INSPECTION REPORT – MUNICIPAL WASTE LANDFILL

Site I.D. 255983
Site Name Bethlehem Landfill Company
Address 2335 Applebutter Road
Bethlehem, PA 18015
Municipality Lower Saucon Township
Responsible Official Astor Lawson
Person Interviewed Astor Lawson, Cody White
Inspector Mathew Vipond
eFACTS ID # PF 268729

INSPECTION REPORT COMMENTS

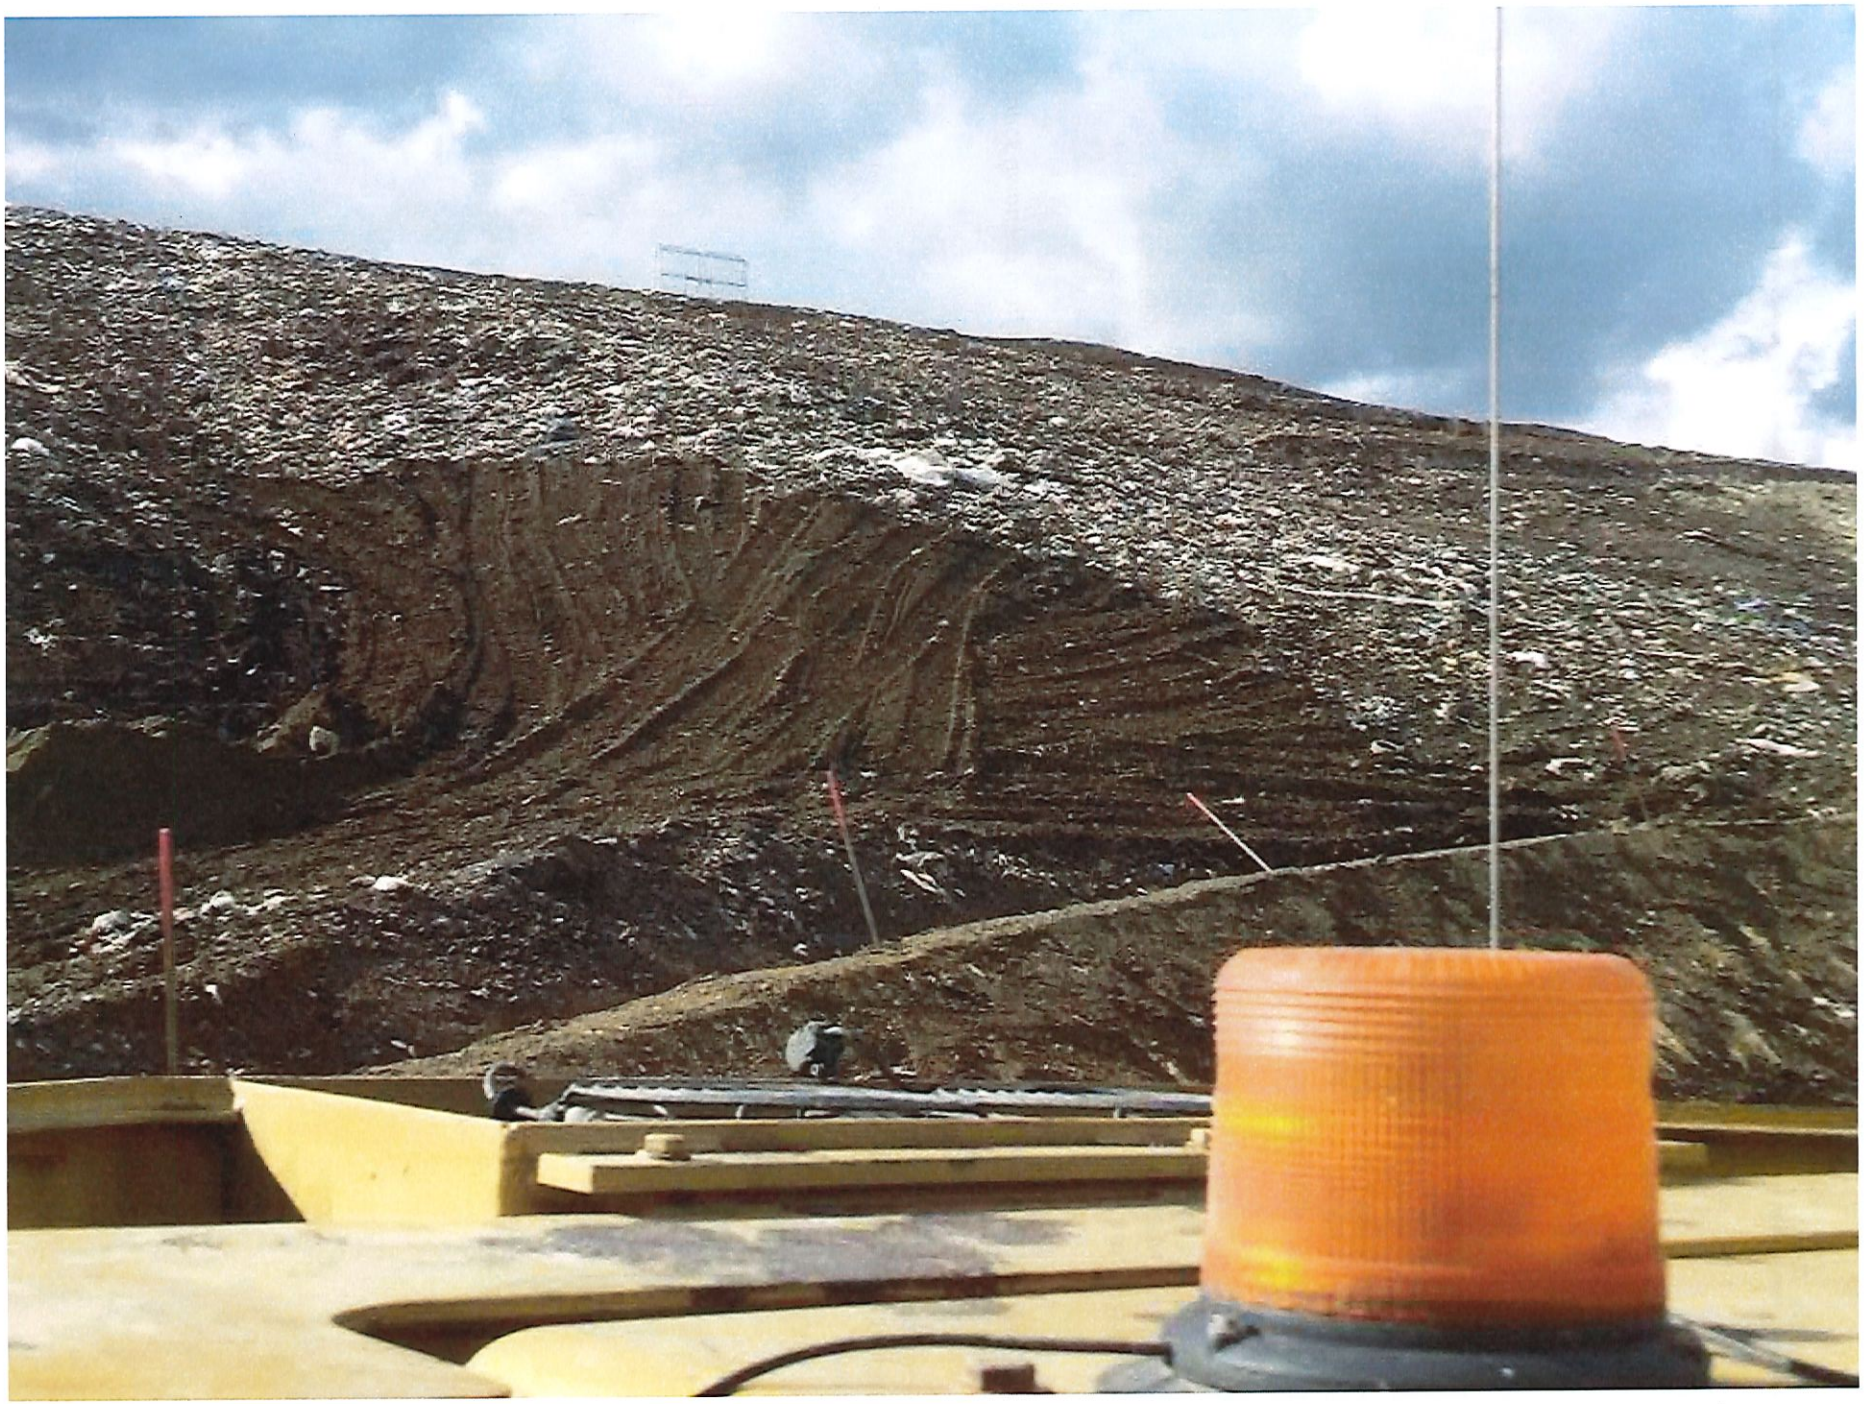
Could you please send me photos of the covered waste at the end of the working day? I would like to see the tarped waste at the toe of the pad where you are currently tipping as well as the larger slope opposite it that we discussed yesterday. I attached the photo from yesterday for the perspective I am talking about.
